# **ANCLOTE HARBOR**

## **#20-106 [PRELIMINARY PLANNED DEVELOPMENT]**

Board of Commissioners, December 8, 2020 (1st Reading)

**CITY OF TARPON SPRINGS**  
**PLANNING & ZONING BOARD / BOARD OF COMMISSIONERS**  
**November 16, 2020 / December 8, 2020 & December 15, 2020**

Figure 10  
A.M. Peak-Hour Total Traffic  
Anclote Harbor Development  
Tarpon Springs, Florida

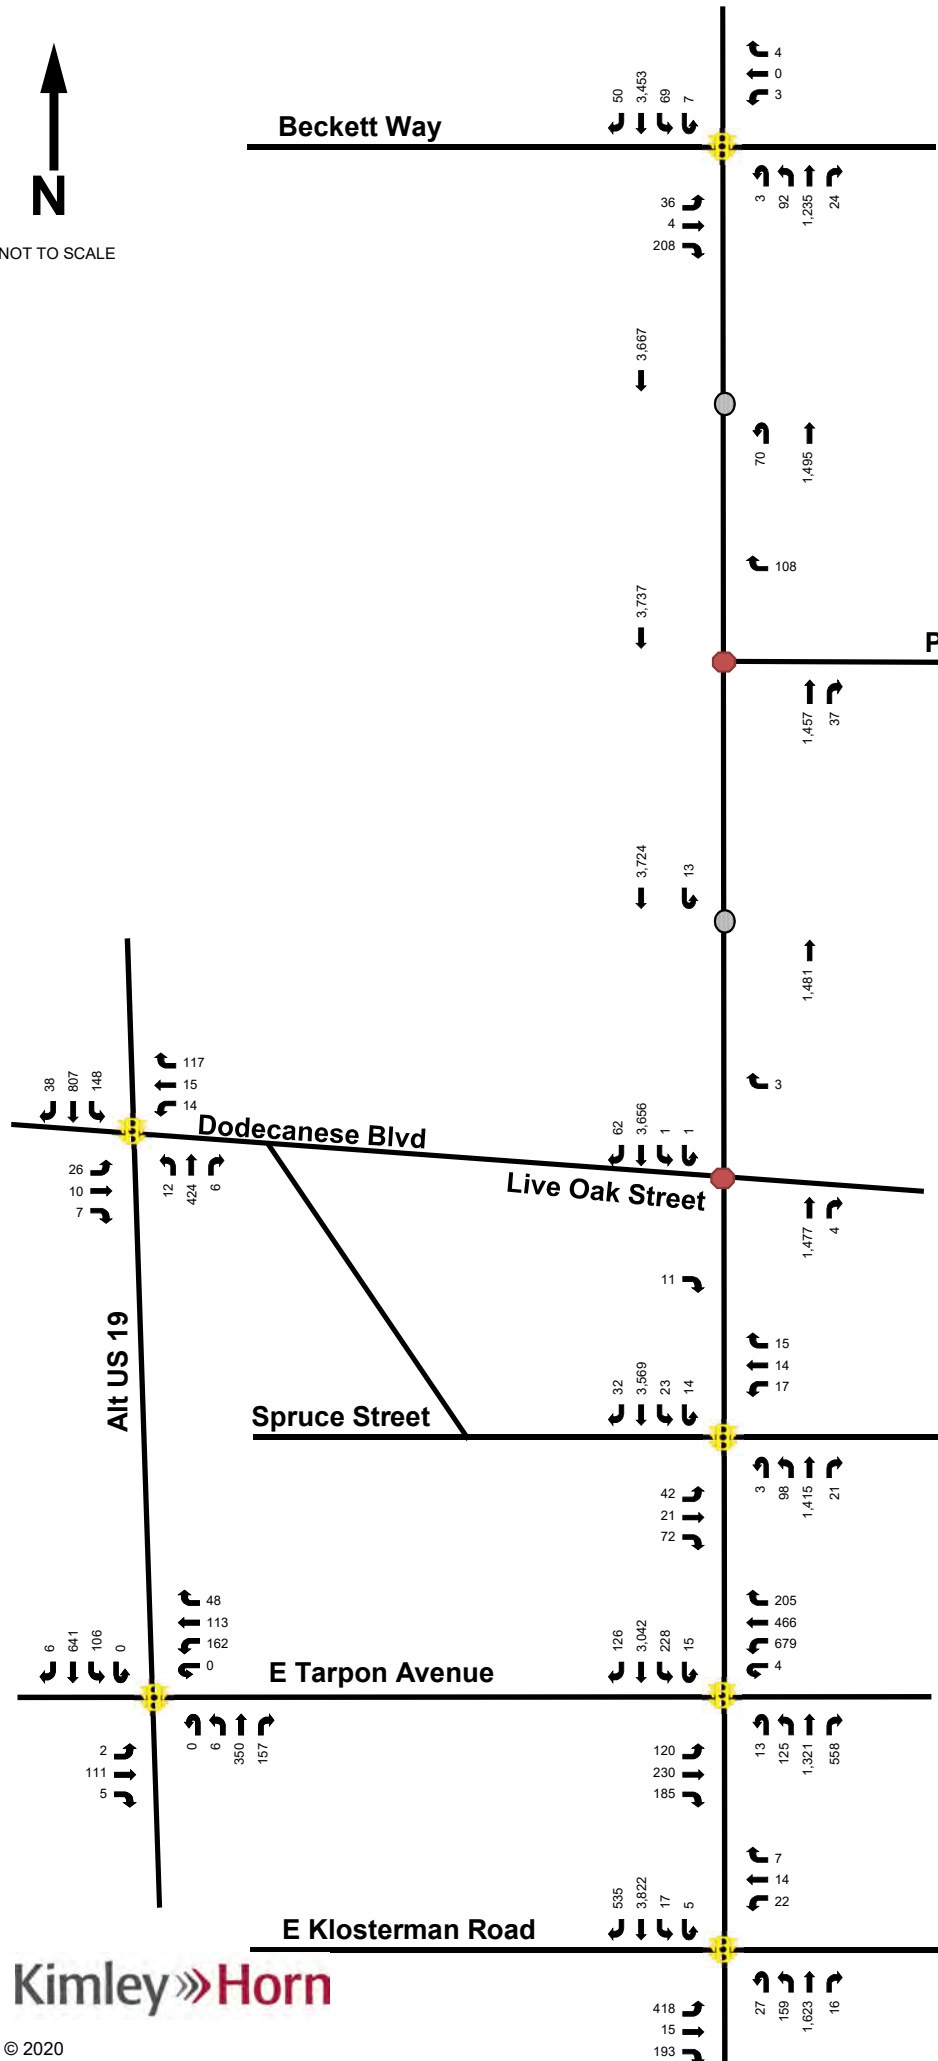
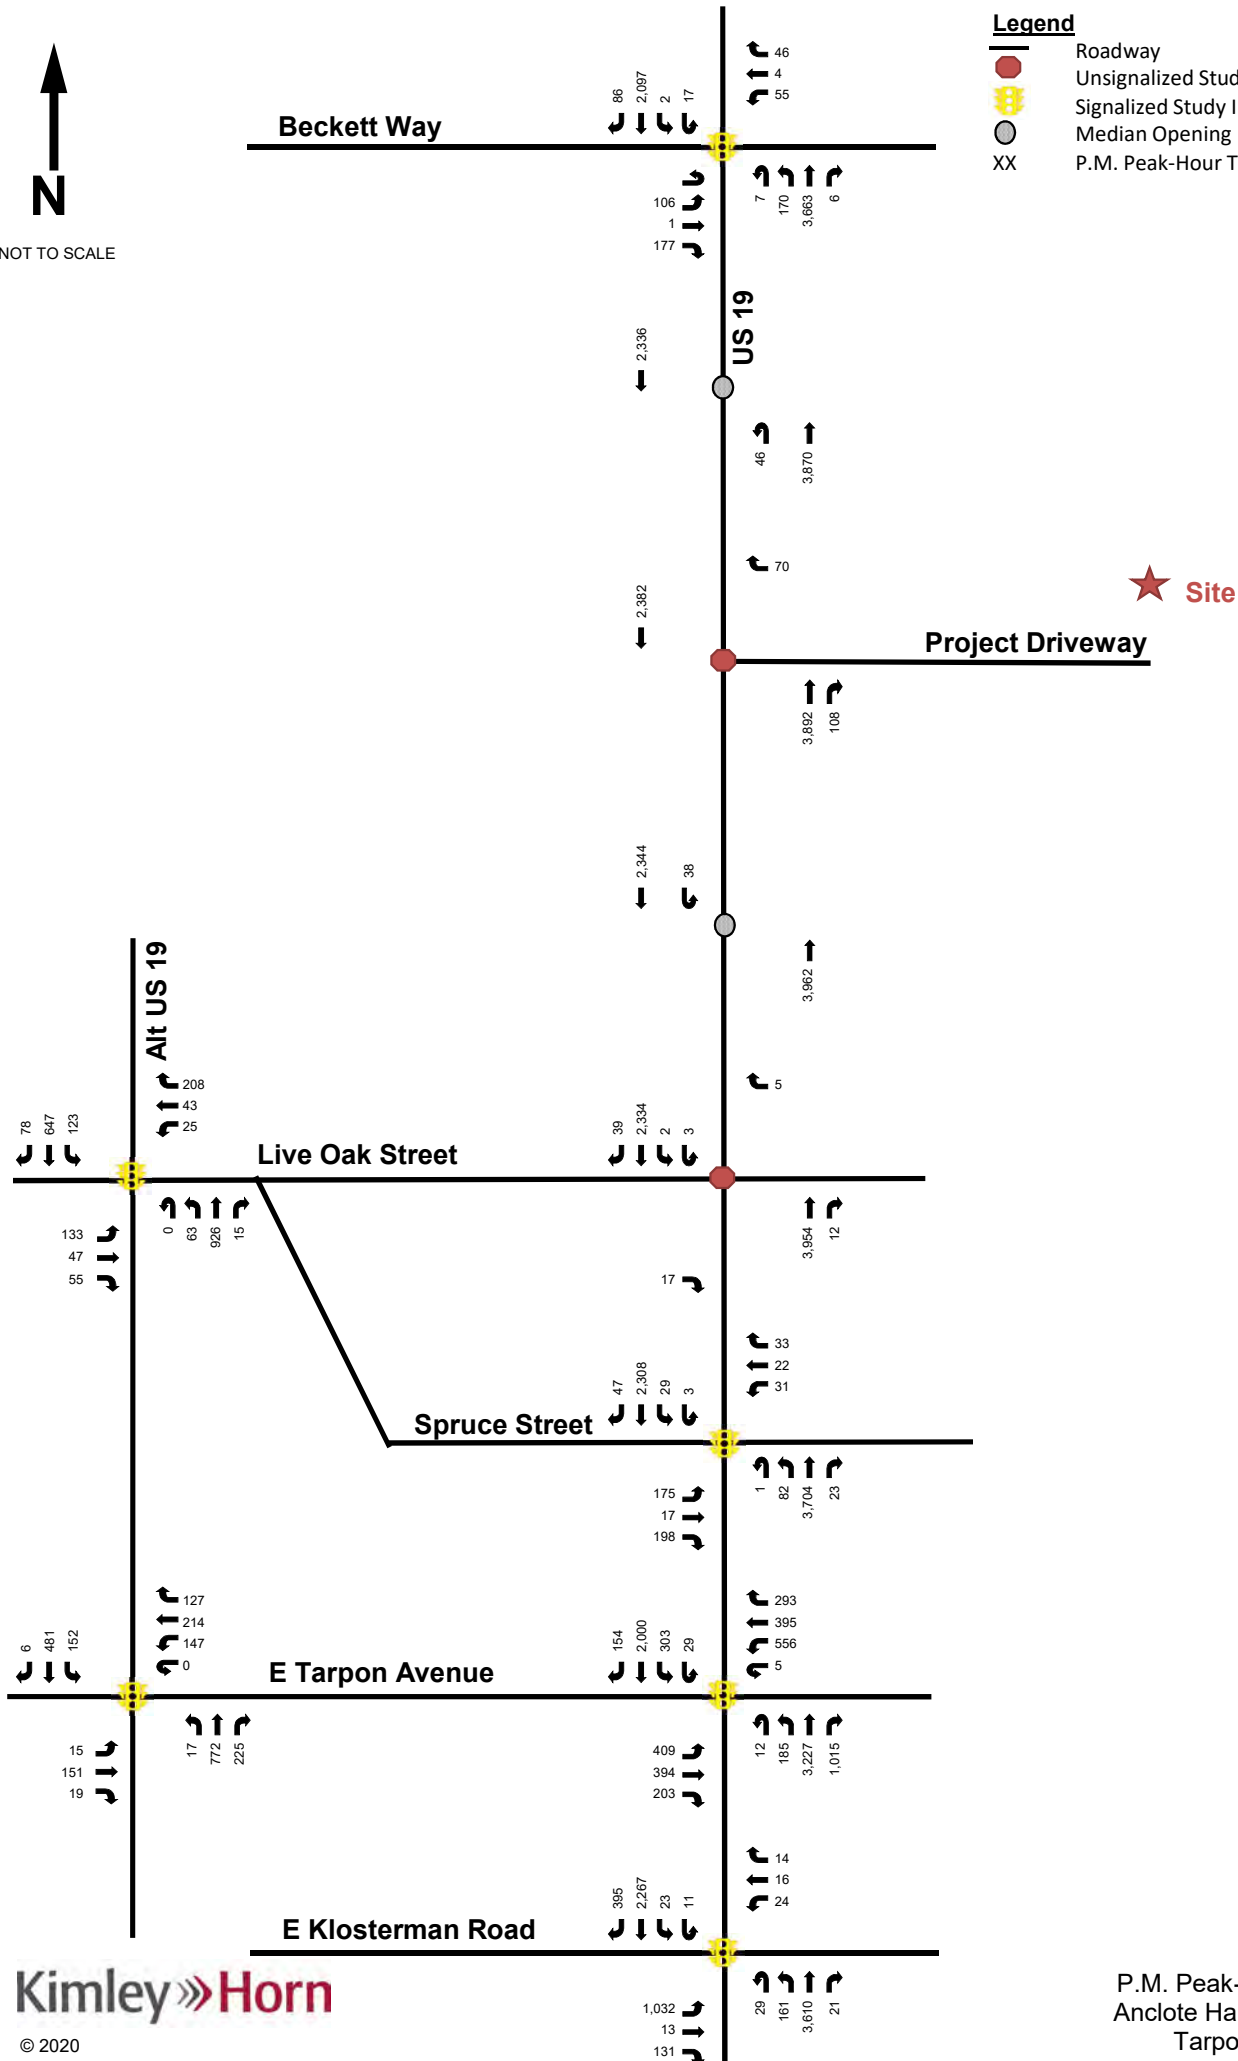
**Response Comment:** Noted that the figures are not to scale, but Figures 3, 5, 7 and 10 do not match the other figure geometry for Spruce Street and Dodecanese Blvd. The geometry should be consistent among all Figures.

**Comment 10:** Comments on Figure 10, 11-

Comment 10: Comments on Figure 10, 11-
